UNITED STATES PATENT AND TRADEMARK OFFICE

Office Action Summary	Application No. 10/598,447	Applicant(s) OAG, JAMIE	
	Examiner JUSTIN JONAITIS	Art Unit 3752

1. The drawings were received on 8/3/2011. These drawings are not acceptable. The drawings contain new matter. The amended figure 1 showing a filter and a nozzle with specific structure has not been specified within the specification. With respect to the specification the specification describes the filter as "a witches broom" and was corrected to read "witches hat" on 8/3/2011. However the specification does not disclose any more specifics than the general type of filter. It does not specify the filter extending into the central chamber or the main chamber. Similarly the specification only discloses the nozzle being designed to produce a fine spray or fog of water but discloses no detailed structure of how this is accomplished. Therefore the detailed filter and nozzle added to figure 1 are not supported by the specification. [page 10, lines 7-14]

The figure below is reproduced from the Allen reference in order to show examiner's interpretation.

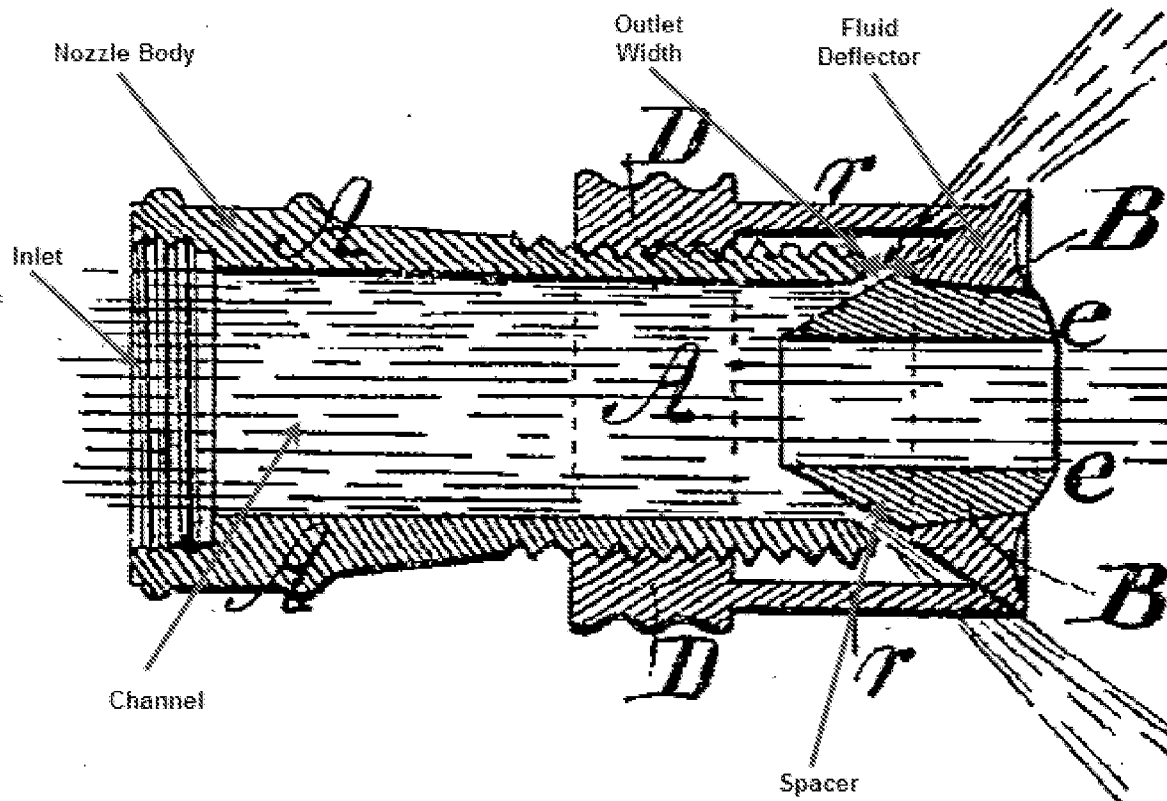
Allen discloses a kit of parts for a nozzle for a hose comprising: a nozzle body (nozzle-piece (A)) having an inlet and an outlet and a channel extending between the inlet and outlet (See Figure above). The apparatus including a fluid deflector and a coupling means (collar (D)) coupling the fluid deflector to the body and arranged near the downstream end of the channel adjacent the body outlet. The fluid deflector and the body together define a width of an opening from the channel at the downstream end. The channel opening width being variable by adjusting a position of the fluid deflector relative to the body.

The body inlet and the body outlet and the fluid deflector are arranged on a longitudinal axis of the body such that the fluid flows from the body inlet along the channel to the body outlet and impinges on the fluid deflector with minimal energy loss prior to impingement on the fluid

deflector. The nozzle comprising a self-cleaning mechanism for adjusting the channel opening width (threaded interaction of the collar and the body is a mechanical mechanism). The fluid deflector determining the direction of flow of fluid as it leaves the nozzle, wherein the fluid leaving the nozzle forms a wall of water.

The deflector being threadably coupled to the body, such that rotation of the deflector relative to the body selectively advances or retracts the deflector relative to the body, thereby facilitating adjustment of the channel opening width.

The channel providing a space suitable for accommodating a spacer to alter the position of the fluid deflector relative to the end the channel, thereby varying the width of the channel opening. (See Figure above)

The figure below is reproduced from the Allen reference in order to show examiner's interpretation.

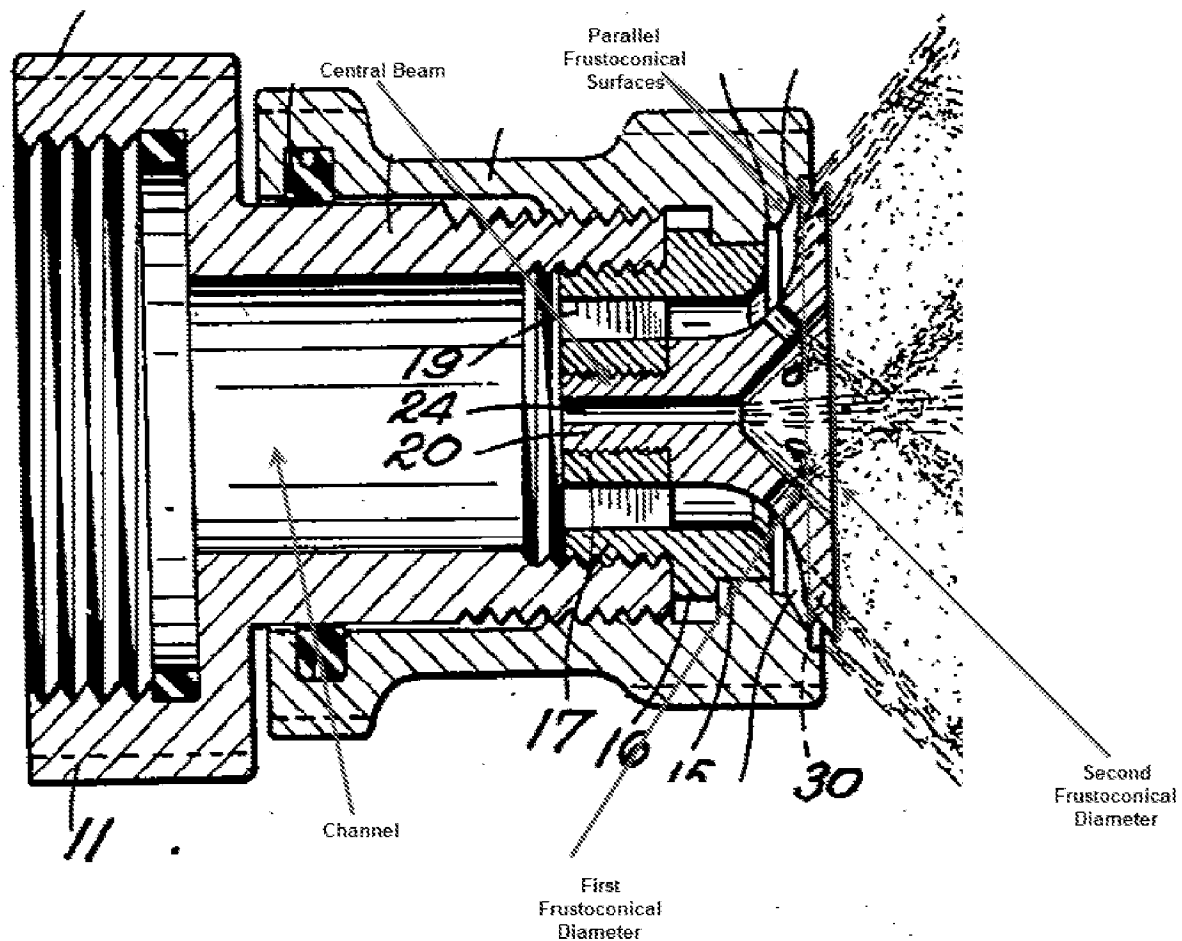
Glessner discloses a nozzle comprising a body (body (10) and sleeve (12)), an annular channel extending through the body from an inlet located at an upstream end to an annular opening/outlet defined by opposing substantially parallel first and second frustoconical surfaces on a downstream end. The first frustoconical surface being formed on the nozzle body, and the second frustoconical surface formed on the fluid deflector. The fluid deflector having an outside diameter that is larger than the outside diameter of the first frustoconical surface. (see Figure above) The angle of the second frustoconical surface with respect to a main axis of the body determines the shape of the water wall formed.

The apparatus including a central beam (see Figure above) disposed in the channel to secure the fluid deflector by being attachable to the body of the nozzle in a position to set a width of the annular opening. Wherein the position of the fluid deflector relative to the body is adjustable via a self-cleaning mechanism (threaded connection between baffle head (20) and thimble (17), is a mechanical mechanism that can adjust the deflector) to vary the width of the annular opening. The width of the annular opening determining the density of the water wall.

The fluid deflector including a deflecting surface positioned relative to the end of the channel to define the width of the first channel opening at the downstream end of the channel. The fluid deflector defining part of the first channel (See Figure, curved portion extends into the channel and therefore defines a portion of the deflector). The deflecting surface disposed at an angle of approximately 105 degrees relative to the main axis of the body such that the deflecting surface is angled away from the direction of fluid flow.

The central beam of the apparatus including a central channel (port (24)) extending through the central beam and through the deflector and the body. The main channel of the nozzle being provided with a space suitable for accommodating a spacer (thimble (17)) suitable for accommodating a spacer to alter the position of the fluid deflector relative to the downstream end of the channel thereby varying the width of the channel opening (threaded portion of thimble portion can be rotated in and out of body (11) to adjust the position of the deflector relative to the end of the channel).

The deflector being threadably coupled to the body such that rotation of the deflector relative to the body advances or retracts deflector relative to the body thereby facilitating adjustment of the channel opening width.

Glessner further discloses a filter coupling (threaded connection on the inlet of the nozzle could be used to accommodate a filter) to couple a filter to an upstream end of the central channel.
